Re: Application to Change Existing Mine Plan, Slurry Pond Abandonment, Hiawatha Coal Co., ACT/007/011.

Title: SLURRY POND ABANDONMENT

Slurry Pond Abandonment Plan.

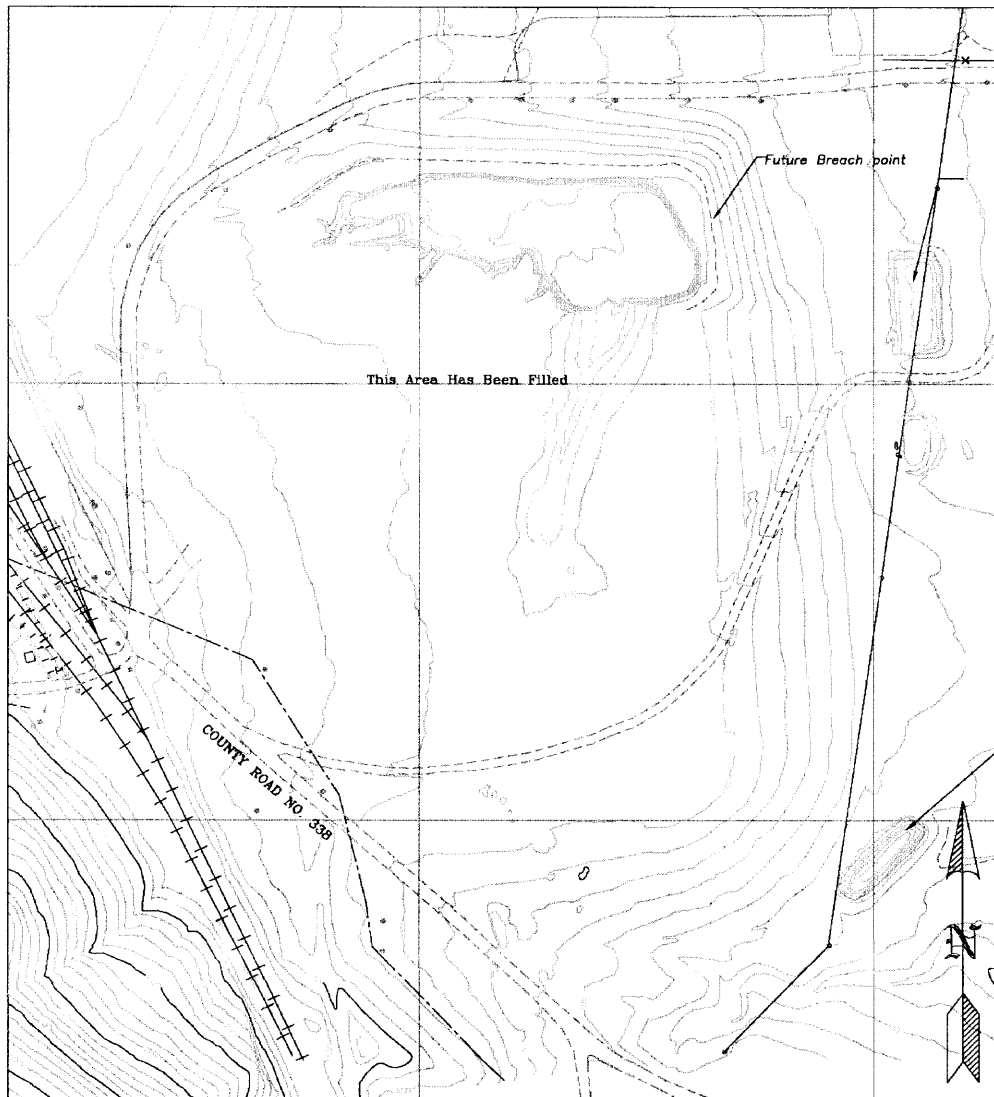
Following approval of the abandonment from MSHA the north bank of Slurry Pond 1, and the east bank of Slurry Pond 5a will be breached so that they no longer meet the requirements of a slurry pond. Slurry Pond 5a will continue to be used as a sediment pond until final reclamation. During this time some coal fine extraction may take place.

During the breaching of Slurry Pond 5a, the material being removed to breach the pond will be placed inside the pond, along the slope going up to the reclaimed main cell of Slurry Pond 5. The pond will be breached above Sediment Pond D006 and all runoff from the construction site will report to pond D006 and will be treated as shown on the following figure.
